(2nd Preliminary) SSMM 17715 Meetinghouse Road,
Sandy Spring
Master Plan Site # 28/11 Sandy Spring Friends
Meeting Hse.

APPLICATION FOR HISTORIC AREA WORK PERMIT

PROJECT:
 Renovated Community House + Addition at
 Sandy Spring Monthly Meeting
 17715 Meeting House Road, Sandy Spring, MD 20880

Staff recommends that the applicant make revisions to the plans based on comments and feedback from the Historic Preservation Commission (HPC) and submit a Historic Area Work Permit (HAWP) application.

Sandy Springs Monthly Htg.
Perspective View
eye level from far side of
parking lot.

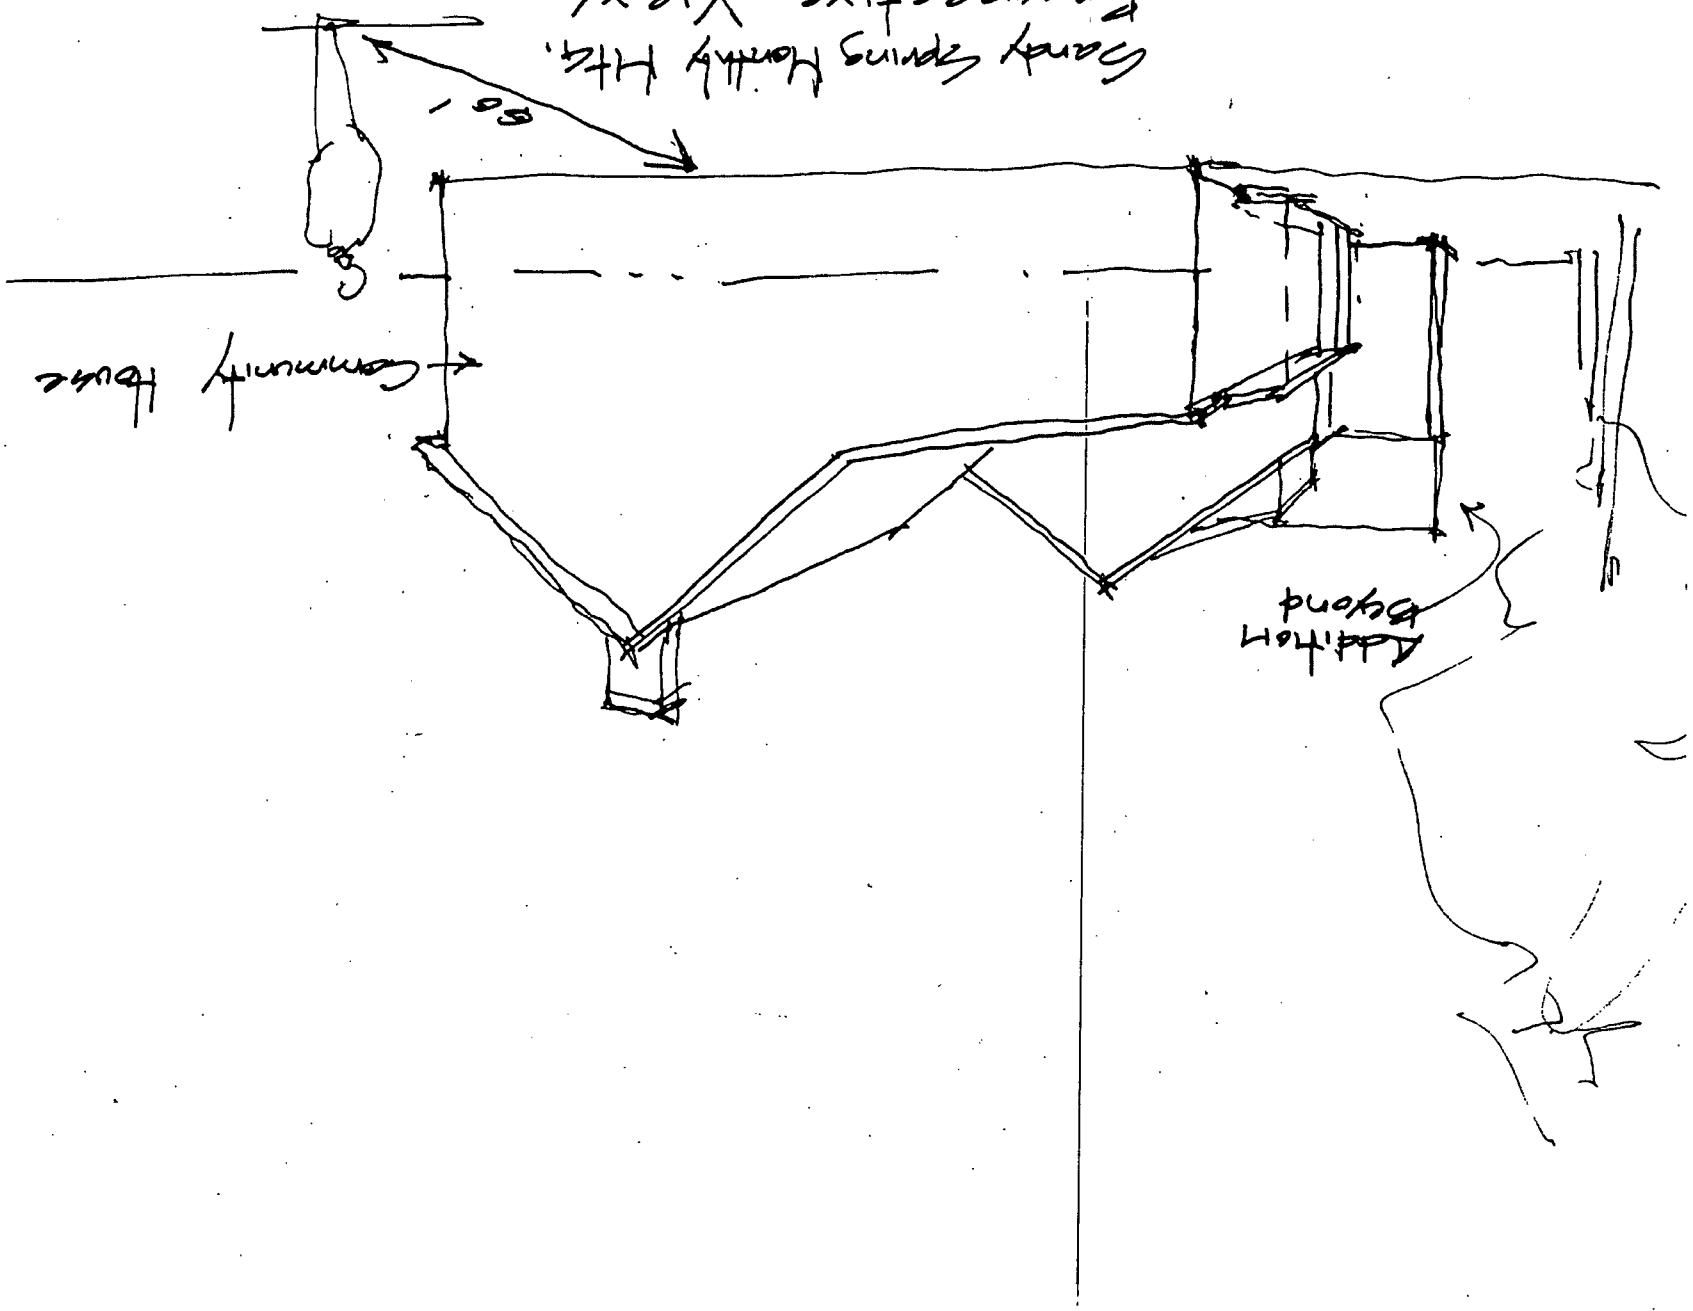
ROBINSON: ✓, but NO "L" (Revised still "L"),
REMOVE 1958 addition —

✓ QUESTIONING RETENTION OF THE 1958 ADDITION → GLASS HYPHEN
MAYBE OK B/C HYPHEN IS INSET BOTH SIDES

✓ — PARKING MODIFICATIONS
